Technical Bulletin

Subject: Engine, Upper Covers Missing at PDI

Number: 03-09

Model(s): Touareg

10-A132

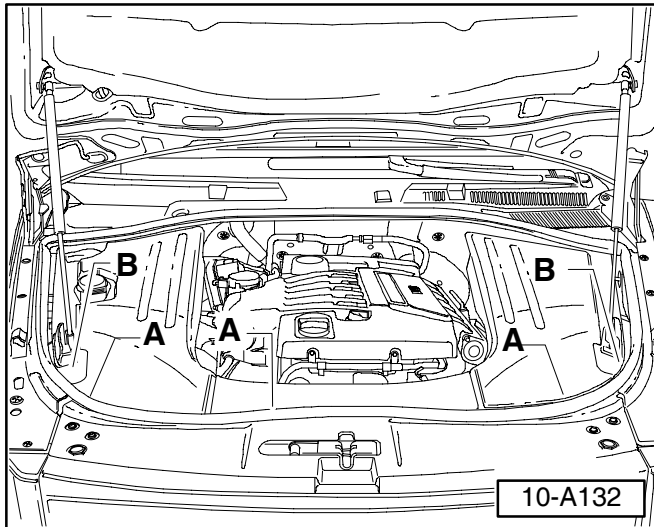
◀ Upper engine covers -A- and hood rod covers -B- are no longer supplied beginning with VIN:

◆ V6: WVGC67L44D028106

◆ V8: WVGCM67L44D028205

10-A133

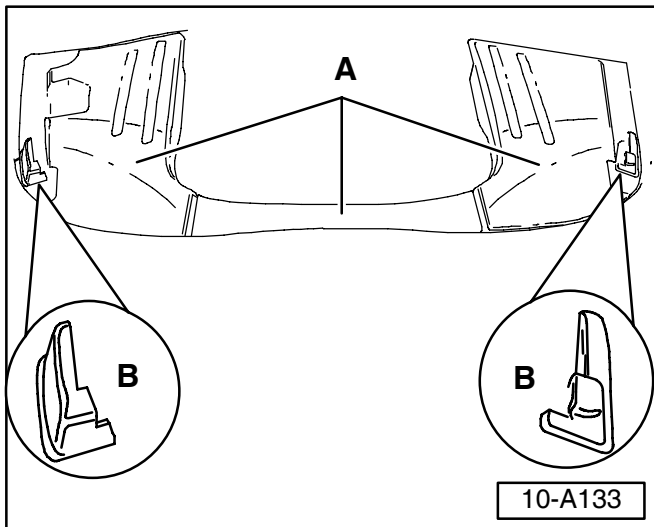
◀ ◆ Vehicles may arrive at Dealership without upper engine covers -A- and hood rod covers -B-.

– NO action is required. DO NOT order and install engine covers.

◆ Covers are not considered missing equipment.
